**EXHIBIT B
DRAFT RESOLUTION**

MCDOUGALL AMY E. (PLN230127)

[PLN230127, McDougall Amy E., 10196 Oakwood Circle, Carmel, Carmel Valley Master Plan, (APN: 416-542-011-000)]

A5

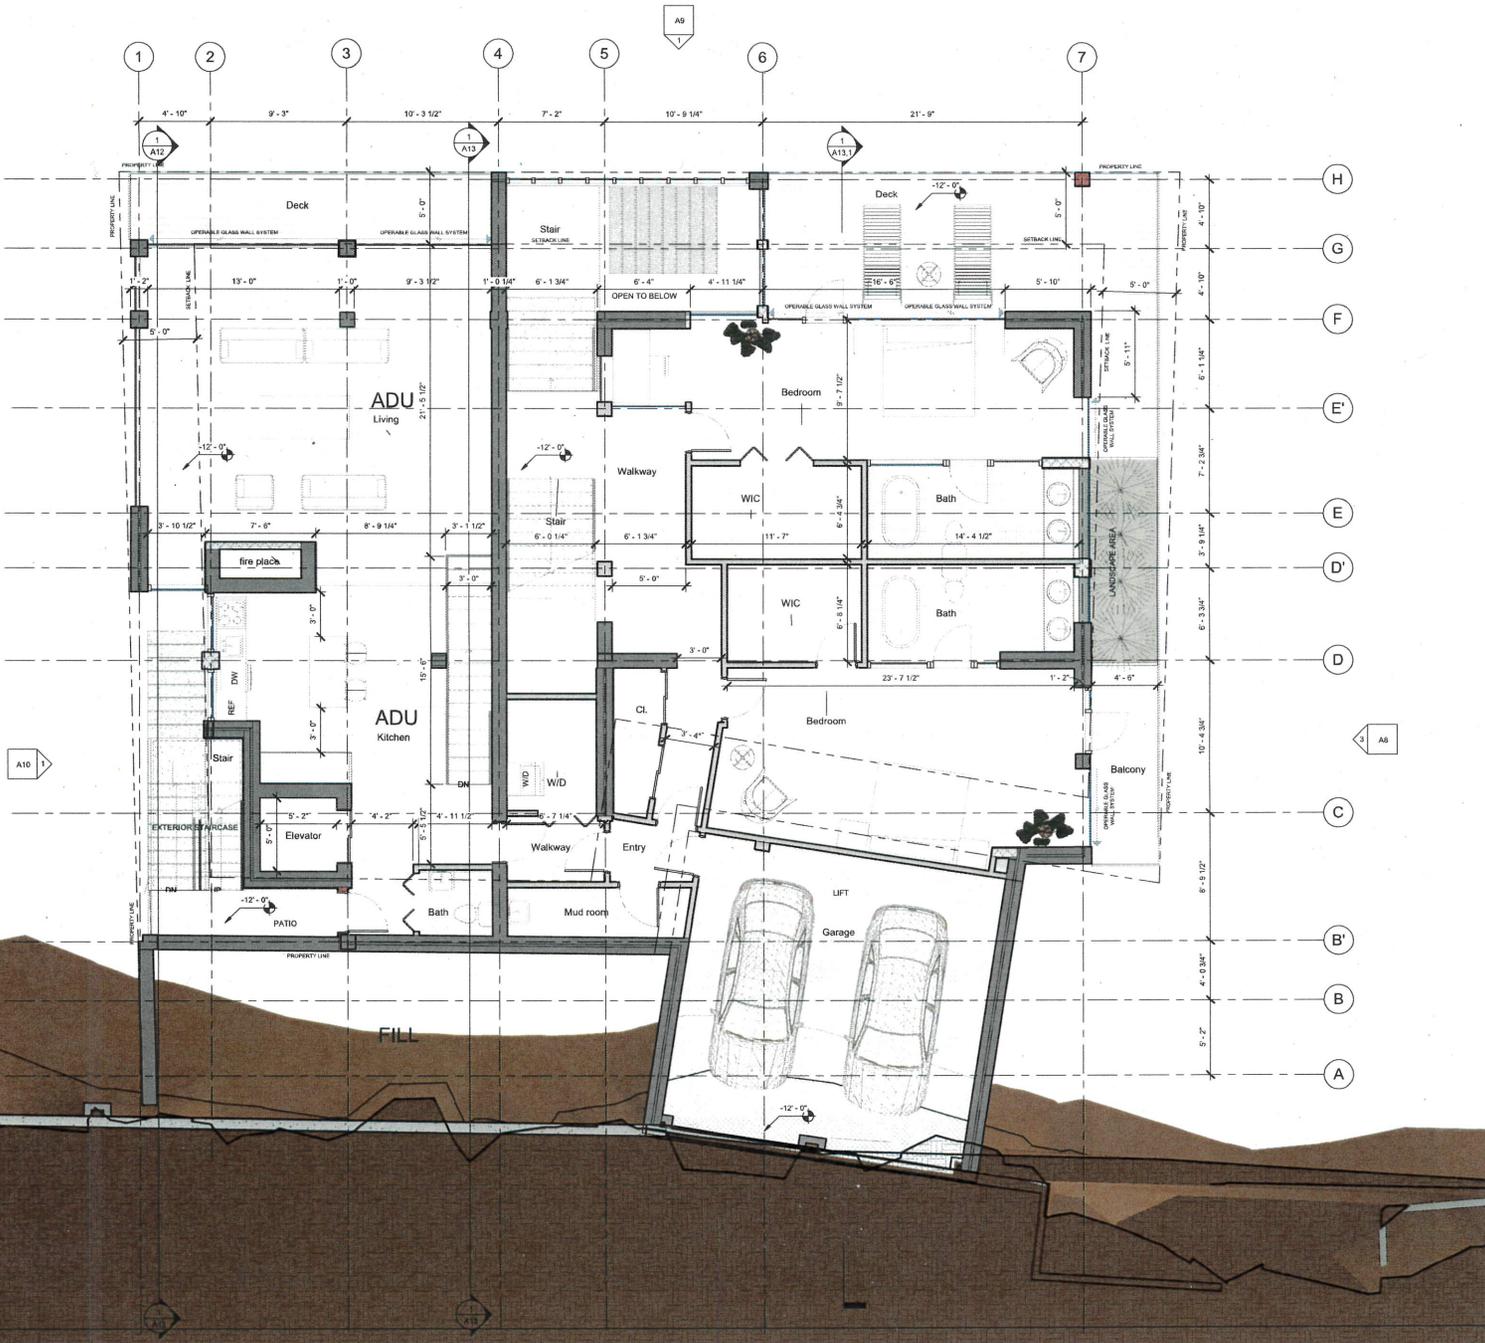
- d) Although the proposed ADU has exterior access via a series of staircases, the ADU also has internal circulation with the main residence (see Sheet A5). Additionally, the lower-level basement and well room are only accessible via the ADU. Consequently, the proposed ADU is inconsistent with the requirement that ADUs be independent living quarters that lack internal circulation with the main residence.

10196 Oakwood Circle - Oakshire Tract	
1045 Carmel Valley Ranch	
Section	
A13	
Date:	09/02/2024
Revision #2	
Scale:	1/4" = 1'-0"

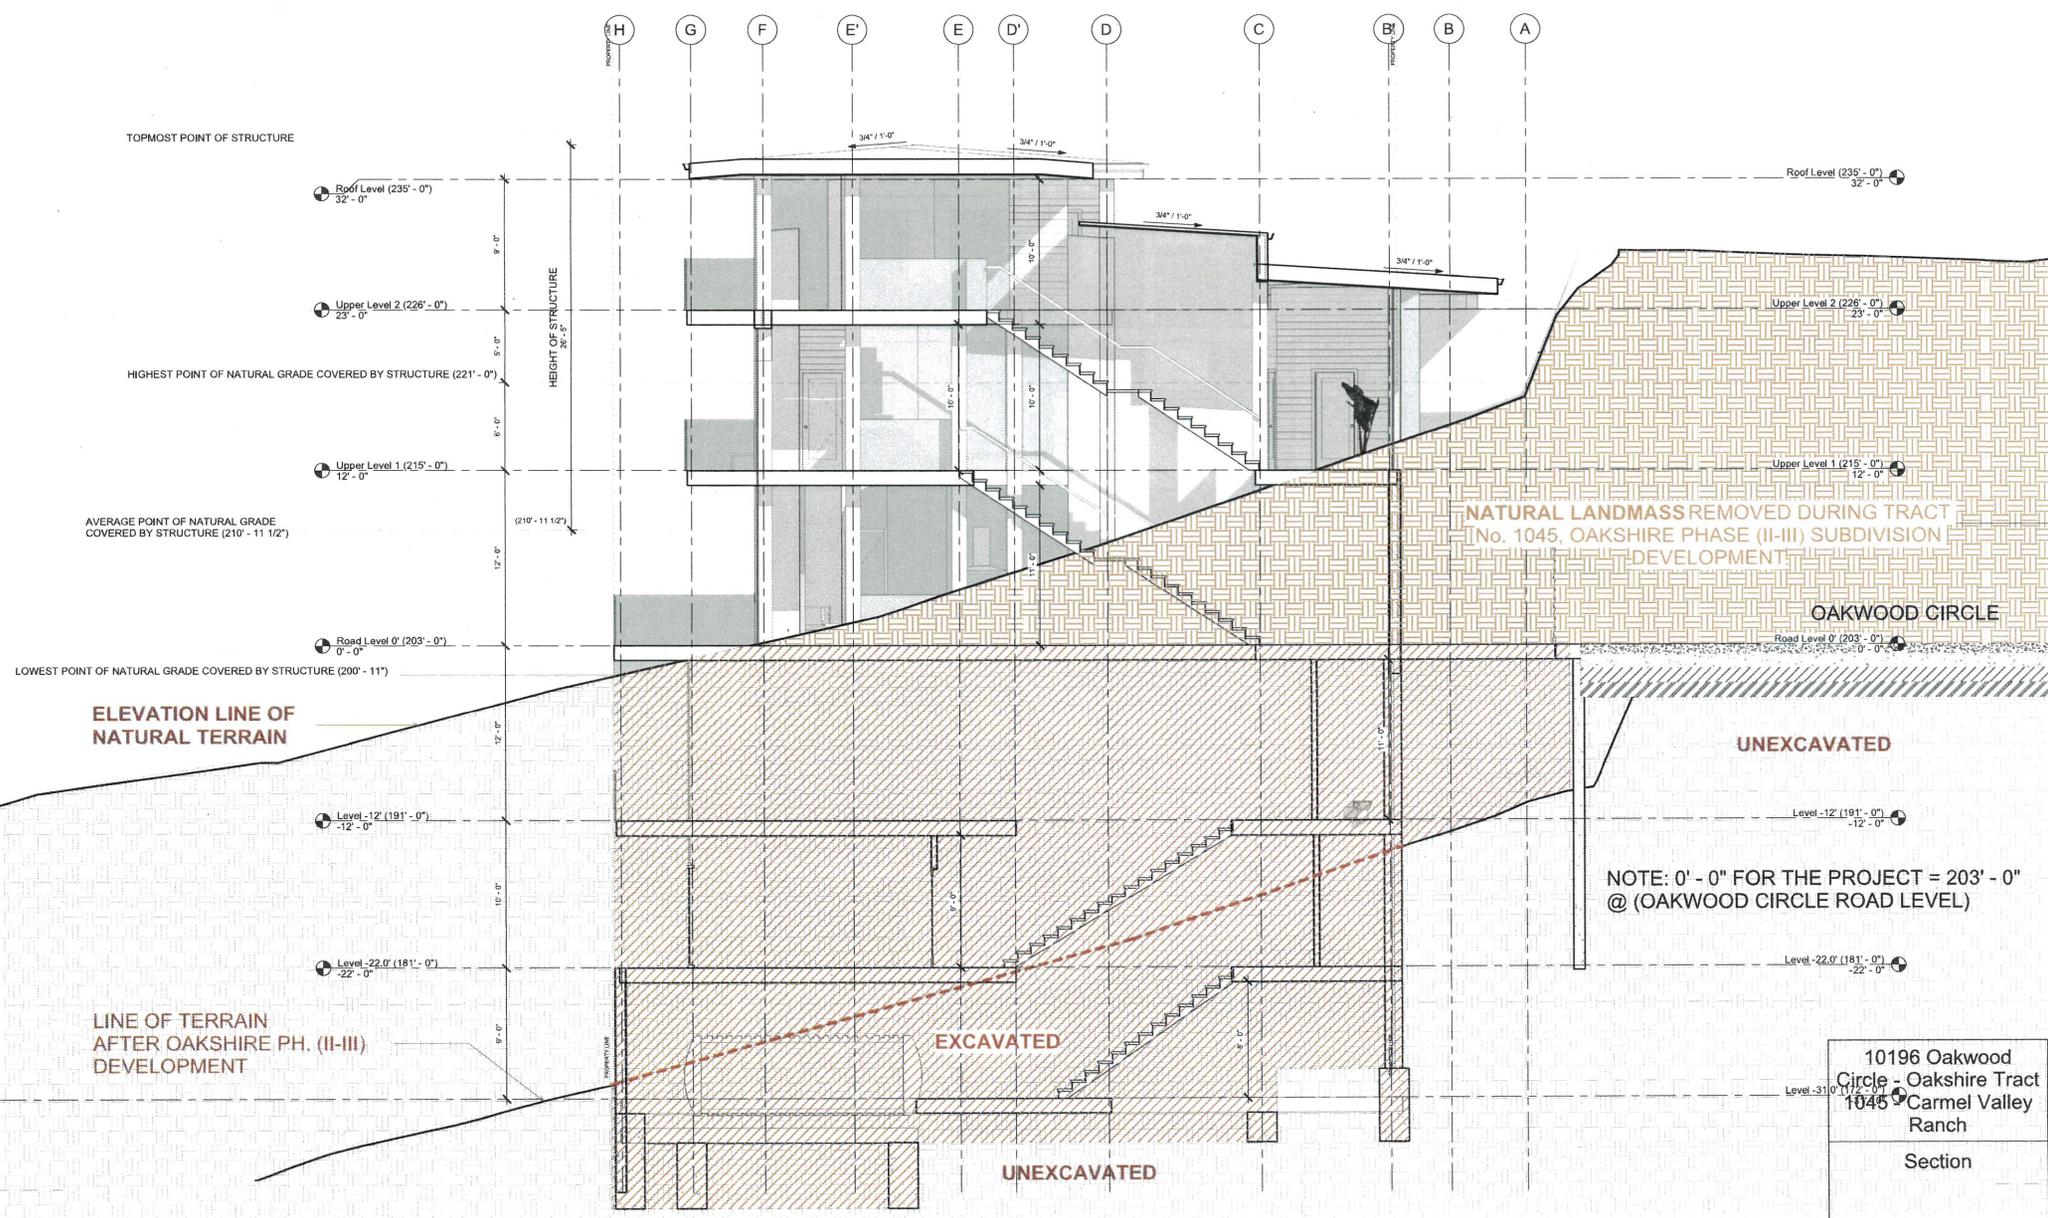
- c) Existing Conditions. Most of the subject property (0.08 acres) contains slopes exceeding 25 percent. Three Coast live oak trees are present and the property is currently vacant. Sheet A13 of the attached project plans illustrates two terrain lines. Based on the prepared topographic survey and United State Geologic Survey (USGS) data, the portion of Oakwood Circle Road that abuts the subject property has elevations above mean sea level (AMSL) of 230 feet to 227 feet. The prepared topographic survey and USGS maps confirm that the subject property, which steeply drops off from Oakwood Circle Road, has elevations of approximately 221 feet to 199 feet AMSL. The current topographical conditions generally correspond with the illustrated “Elevation Line of Natural Terrain” on Sheet A13. Contrary to this information, the project plans erroneously illustrate Oakwood Circle Road and site conditions approximately 27 feet below current conditions - 203 feet AMSL for Oakwood Circle Road and 174 feet to 194 feet AMSL for the subject

property. These nonexistent elevations are depicted as the “Line of Terrain After Oakshire Ph. (II-III) Development” on Sheet A13. The attached plans and prepared technical reports incorrectly assume that the “Line of Terrain after Oakshire Ph. (II-III) Development” represents current conditions. The project plans estimate 1,272 cubic yards of cut, with 875 cubic yards of fill. However, as shown on Sheet A16, the project’s estimated earthwork is based on the “Line of Terrain After Oakshire Ph. (II-III) Development” and thus only accounts for the lower two levels. Based on existing topographic conditions, three and a half levels of the proposed six-story residence are subterranean.

Approximately 35 to 45 feet would be excavated to accommodate these subterranean levels. Staff’s calculations estimate that the project would require approximately 4,864 cubic yards of cut. By utilizing a grade condition that does not exist, the project plans and related technical reports dramatically underestimate the ground disturbance and related site alterations necessary to support the project, as well as the resulting environmental impacts.
